Shenzhen Changtai Electronics Co., Ltd

Request of Class II Permissive Change

Company name: Shenzhen Changtai Electronics Co., Ltd
FCC ID: 2AURH-V25Z
FCC Part 15 Certification

Comparison Photos:

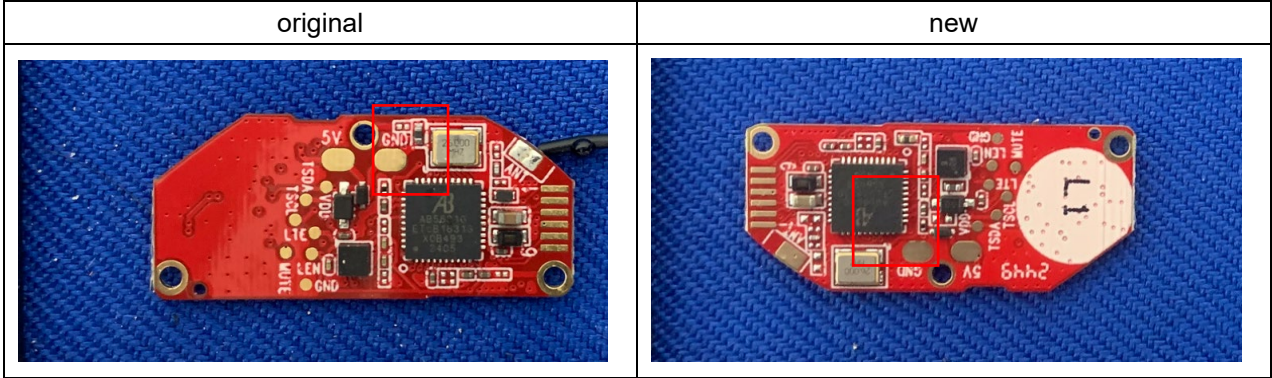
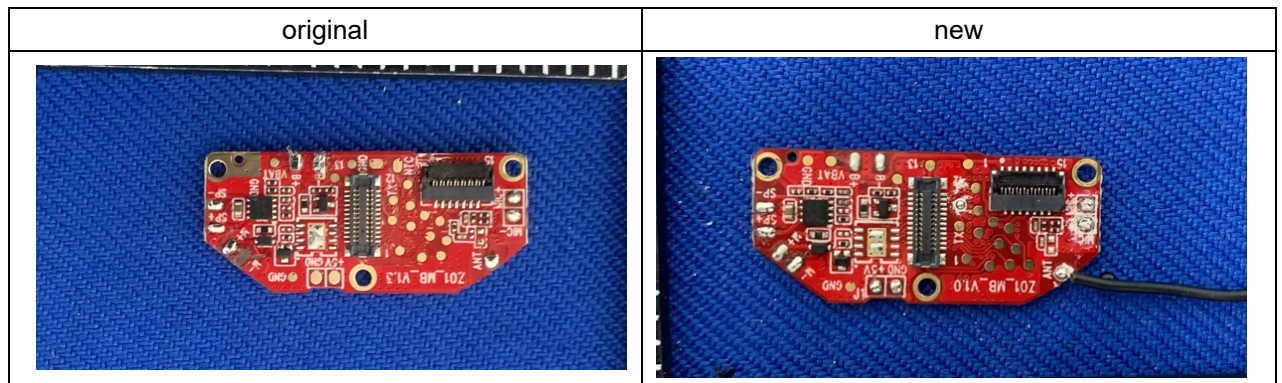
- 1. Add indicator light to PCB board;
- 2. Add battery model and battery photo;
- 3. Update model information and add series model photos;
- 4. Update external photos and internal photos.

All others are the same in electrical parameters and internal circuit structure. Therefore, re-tested conduction emission, radiated emissions and pre-tested the conducted output power, the test results are less than or equal to the original value, so the test data was refer to the original reports.
